CUSTOMER TECHNICAL MEMO

Subject HE958 Hunter EVO Acoustic
Frame Sill

Date: October 2016

Code	Description
1600858	HE958 Hunter Evo Acoustic Frame Sill

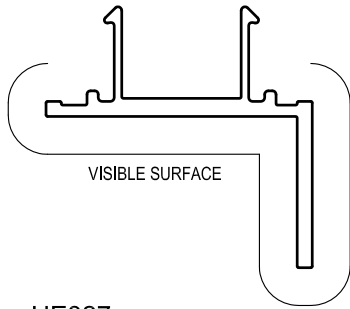
We are pleased to advise we have released a new sill section to suit our 150mm Hunter Evo Acoustic Framing (refer attached page).

As this section is open backed and not a hollow, it now facilitates masonry anchor clearances. Previously the hollow sill / transom HE954 needed to be relieved for these fixings.

HE954 now remains as a transom.
